# **HDC**

## **ADMINISTRATIVE APPROVALS**

<b>May 07, 2025</b>
---------------------

DRAWING TITLE:  
ELECTRICAL SERVICE  
PEDESTAL

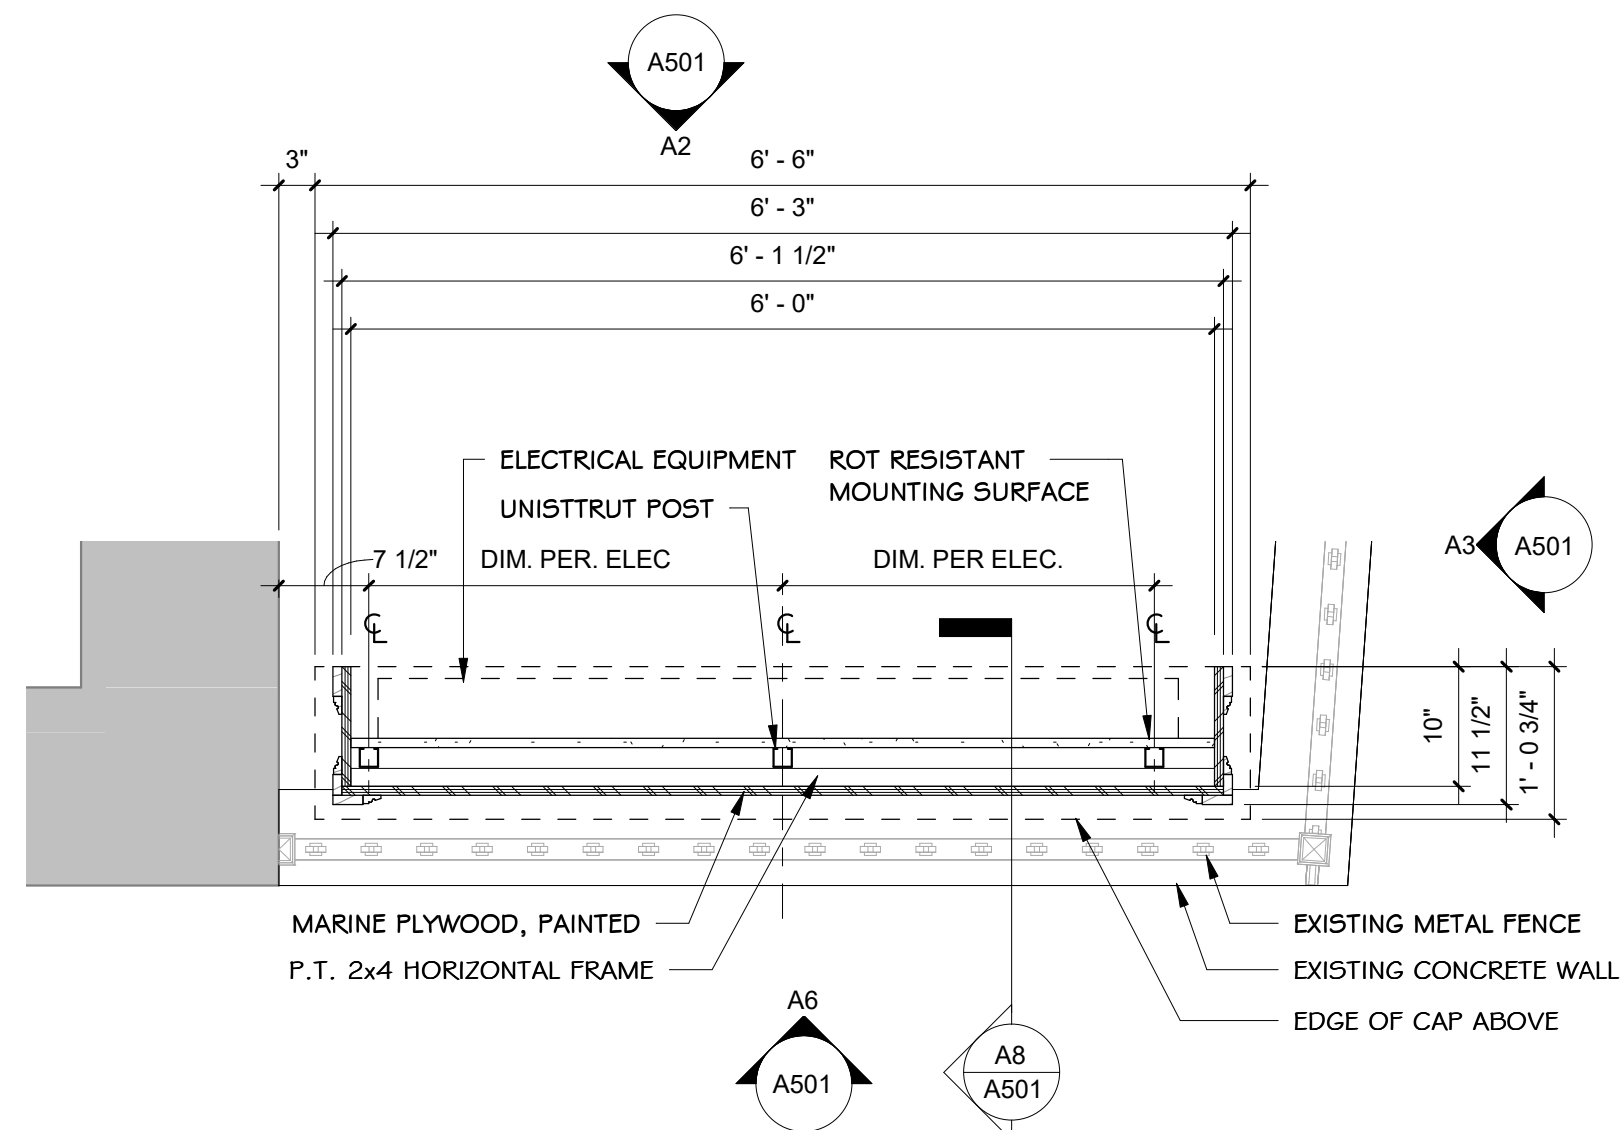
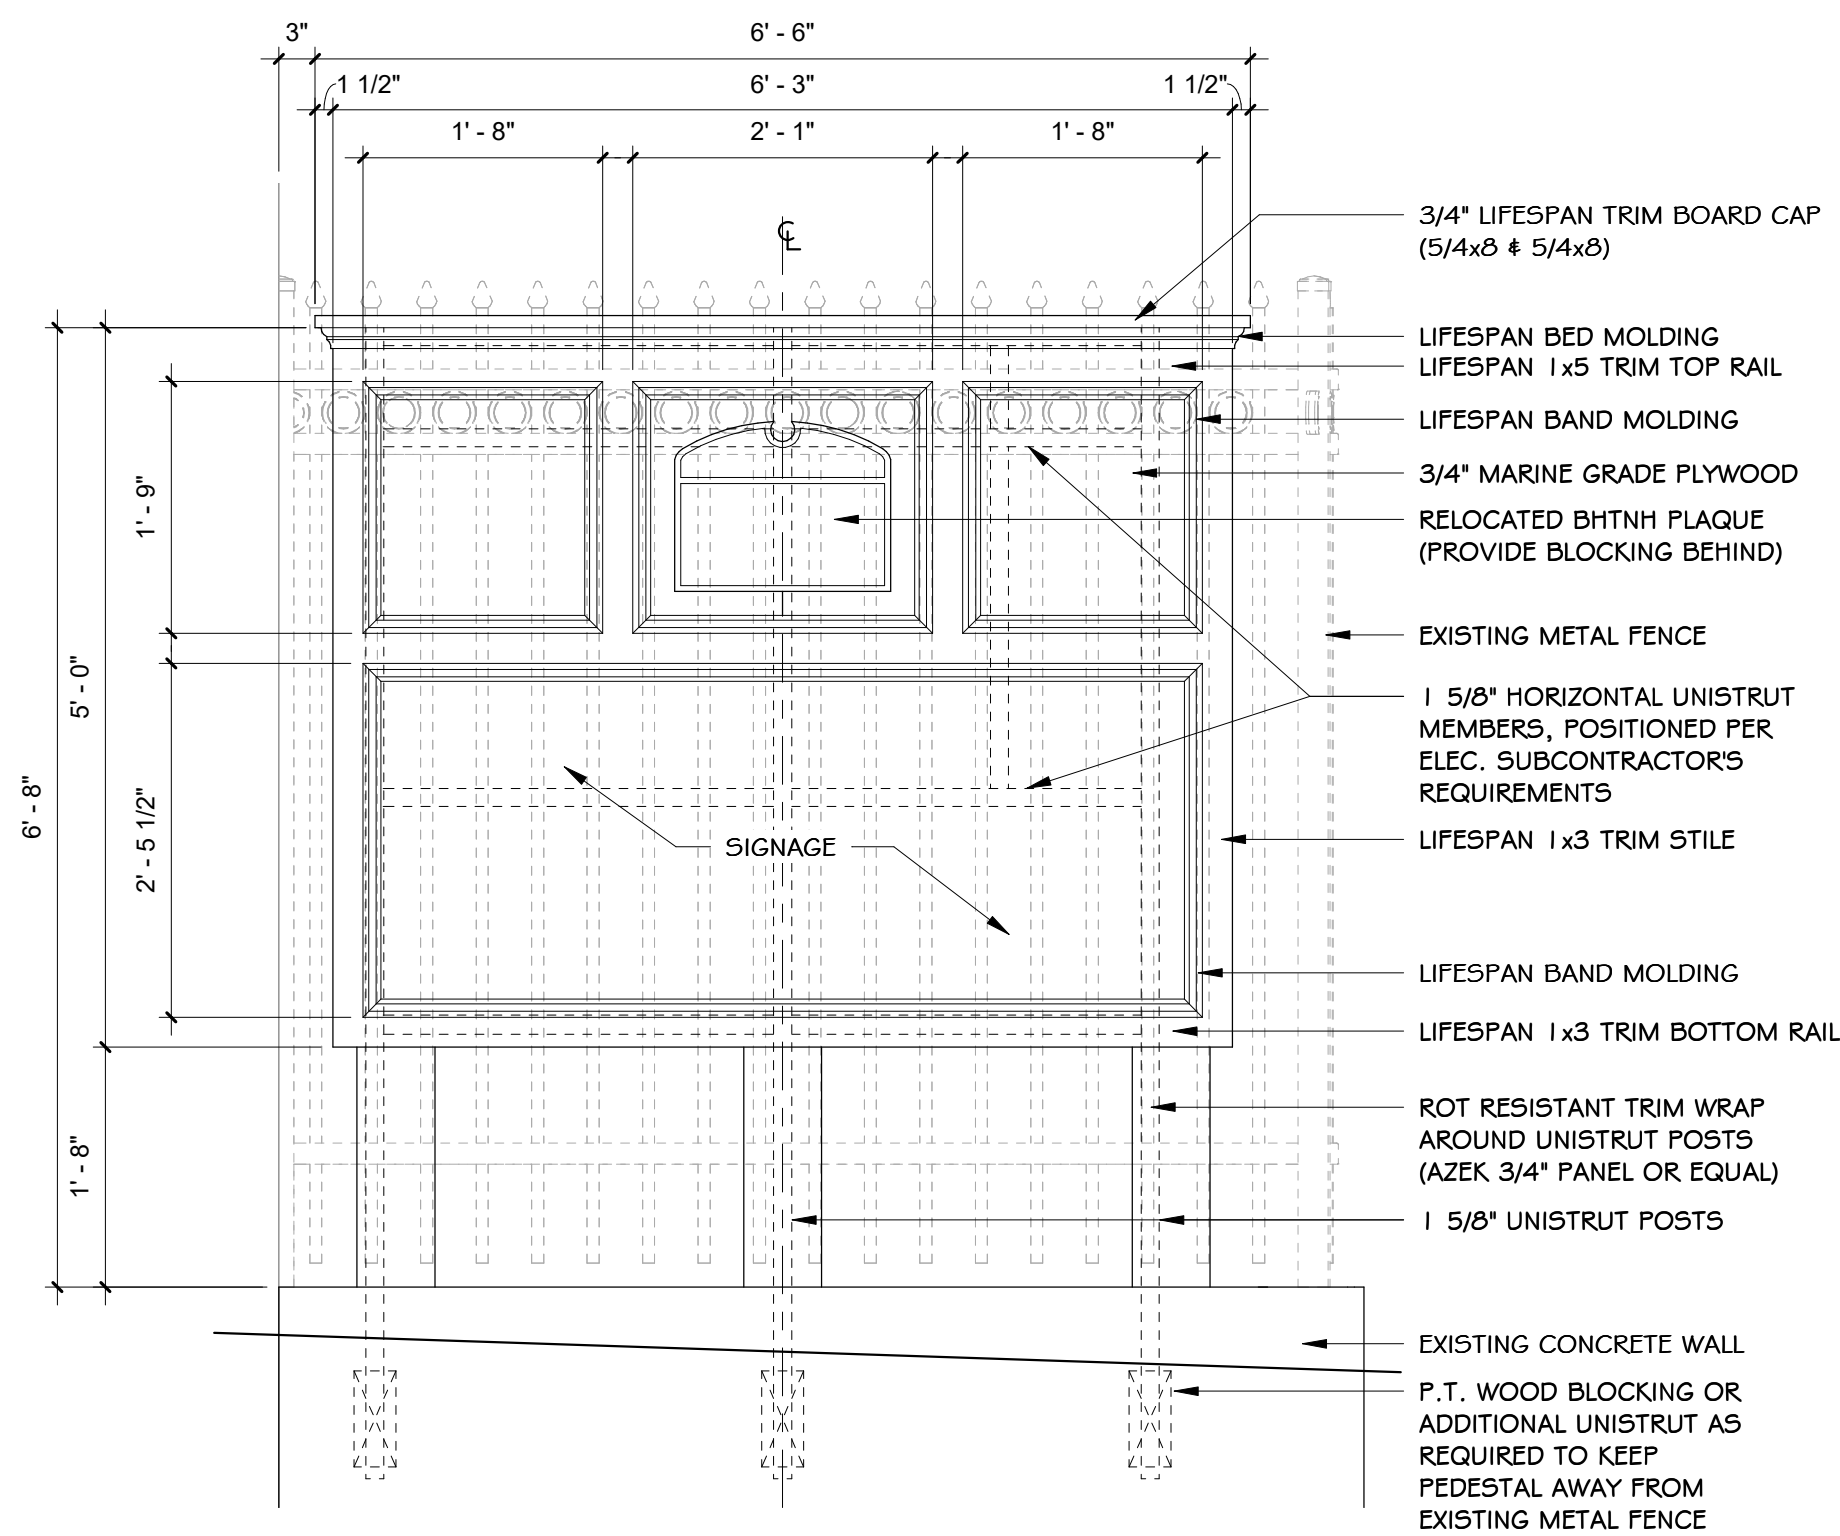
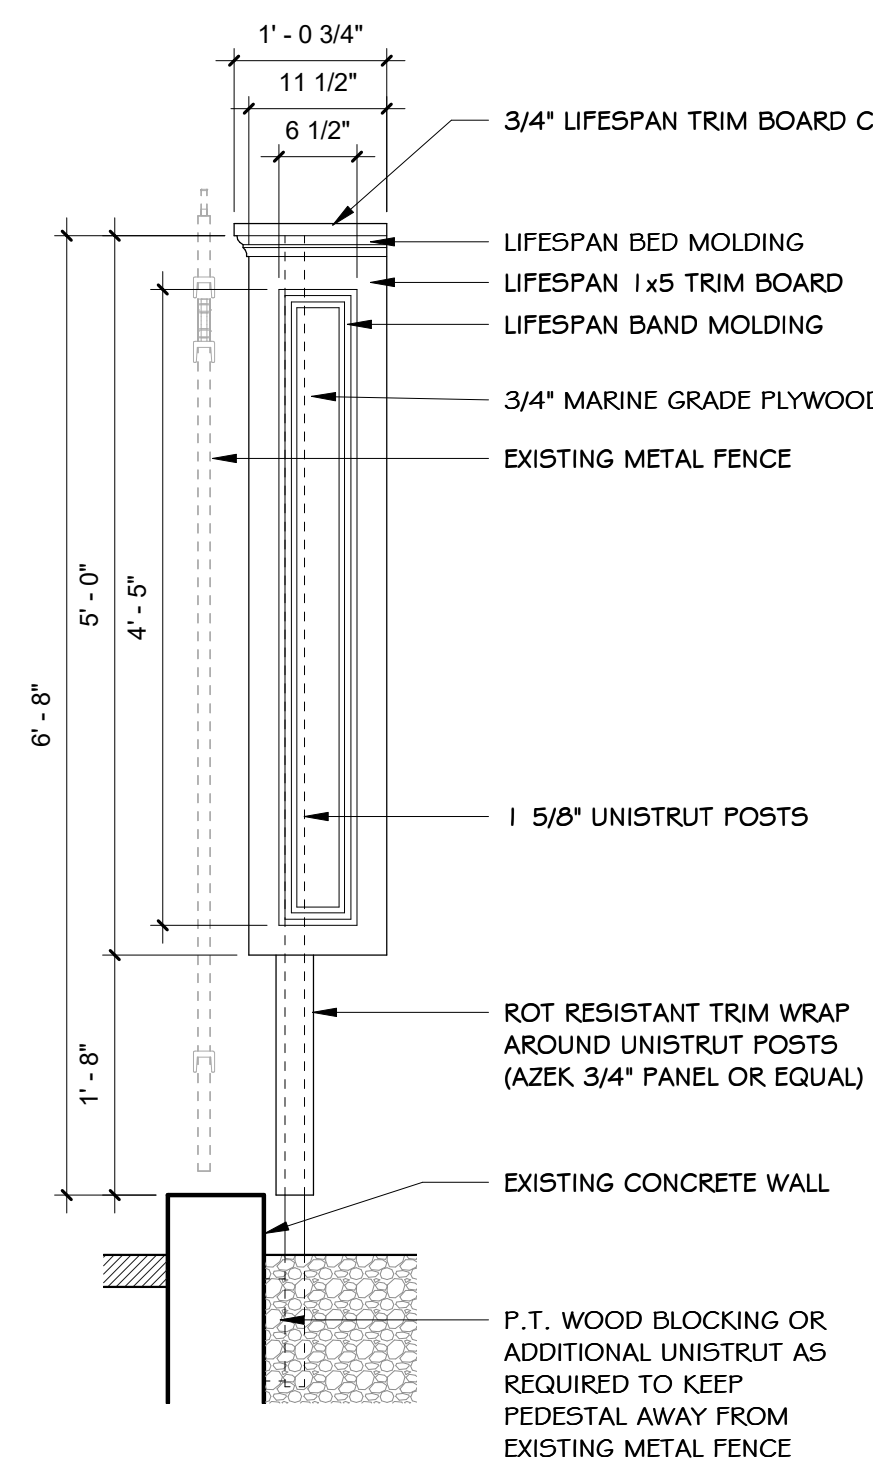
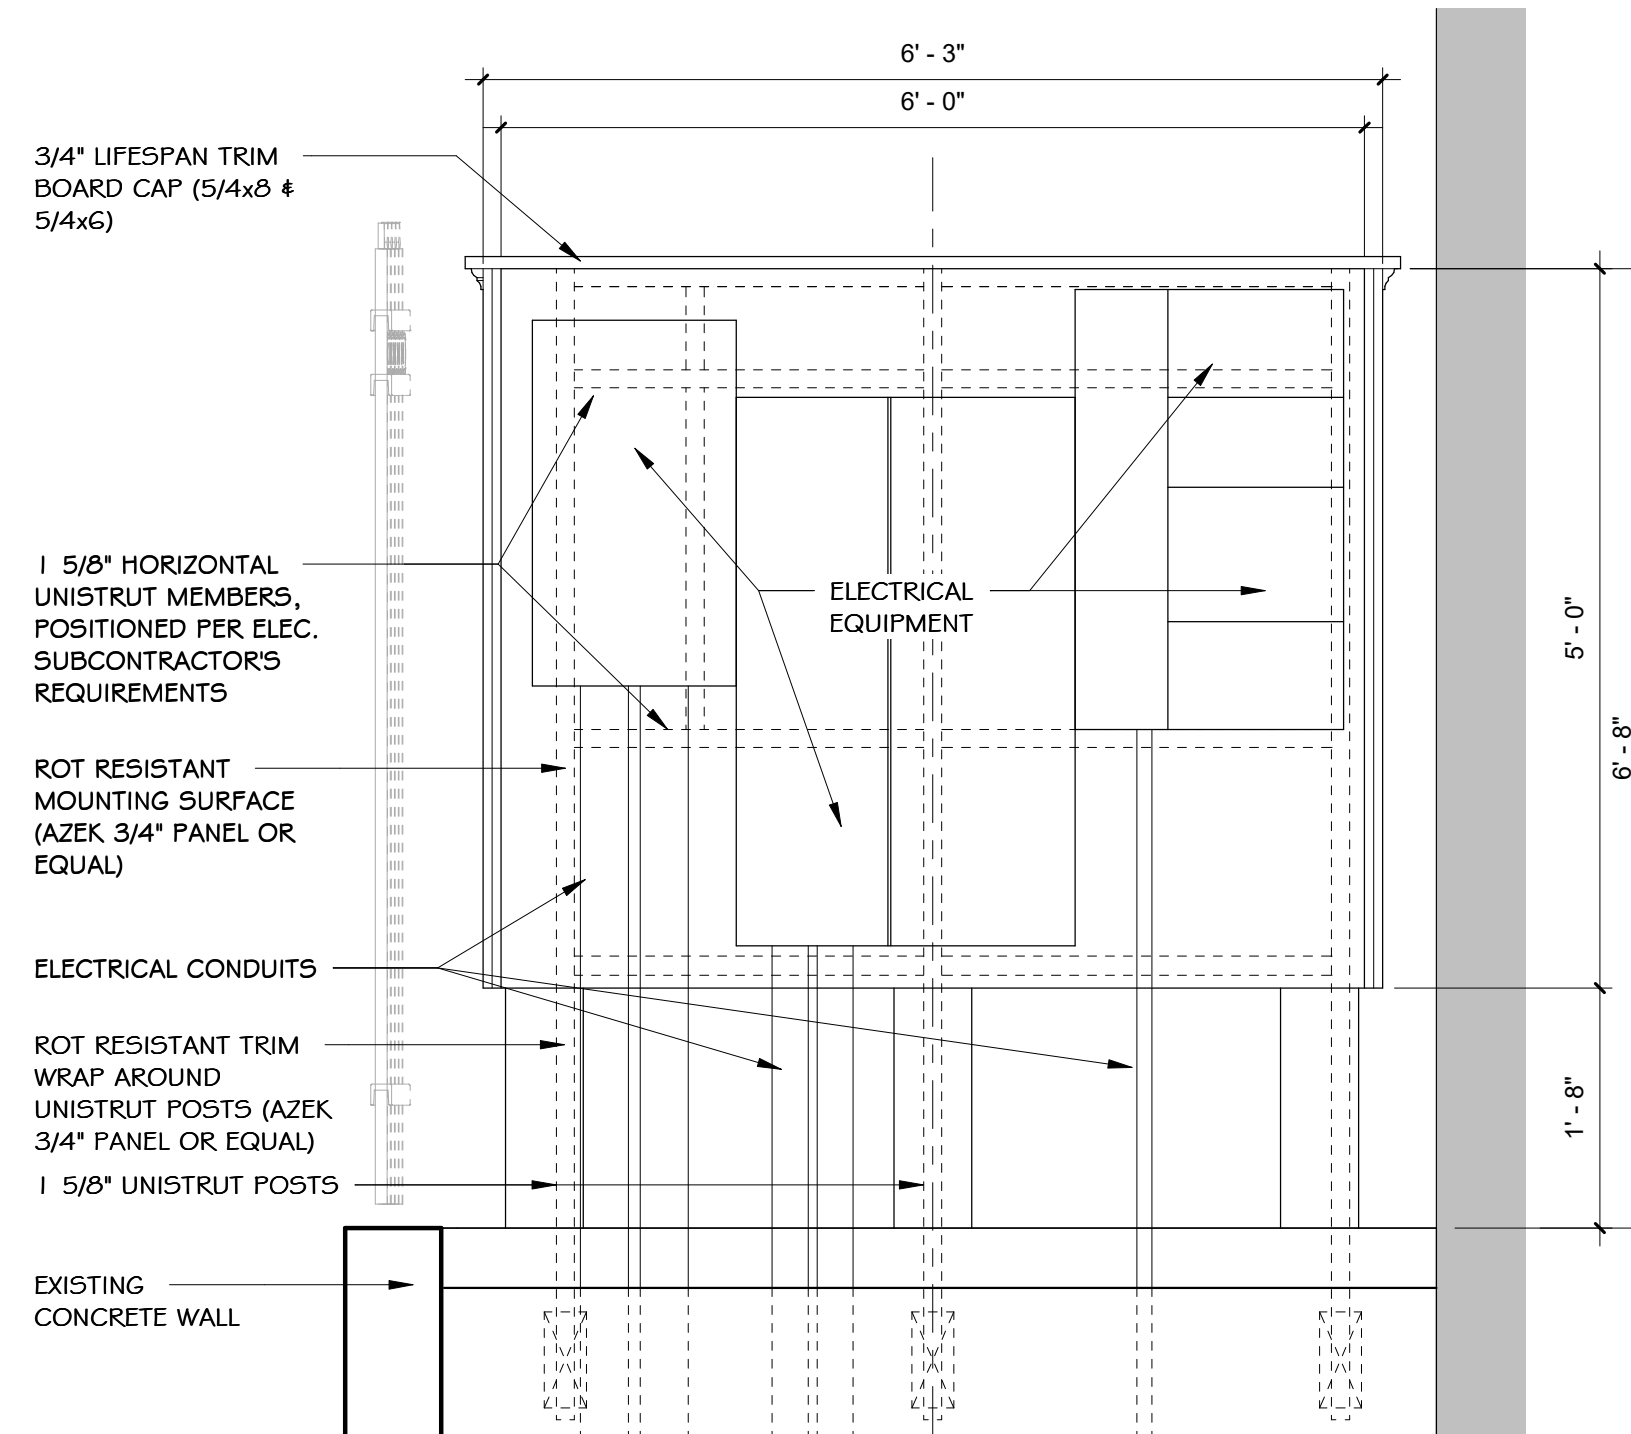
**Background:** The applicant is seeking approval for the removal of the electric meters on the building and move them to a free-standing panel.

**Staff Comment:** Recommended Approval
